JIG SAW

Model 4320

SERVICE CHANGE

1. Change on Slider and Housing from S/N 52,556E.

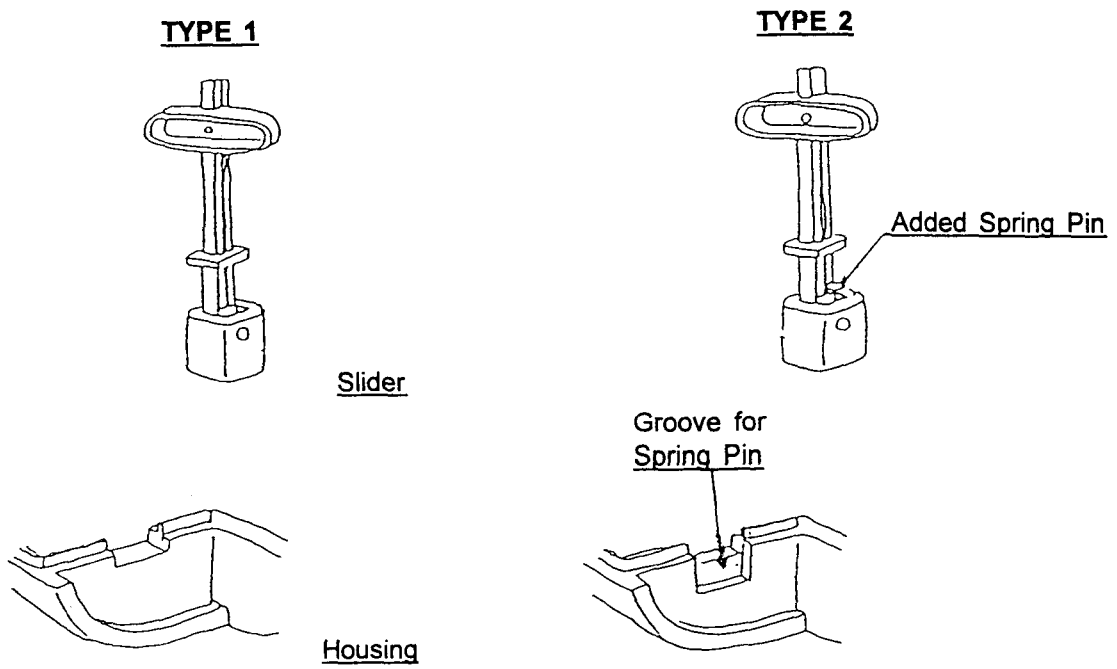
Fig.	Description	Type 1	Type 2
2	Slider	Part #154362-9 (Discontinued)	Part #154398-8
7 28	Housing Set	Part #182166-9 (Discontinued)	Part #182375-0

The above parts are completely interchangeable as a set, except Type 2 Housing fits Type 1 Housing individually.

Type 2 Slider fits Type 1 Housing if you remove added Spring Pin from Type 2 Slider.
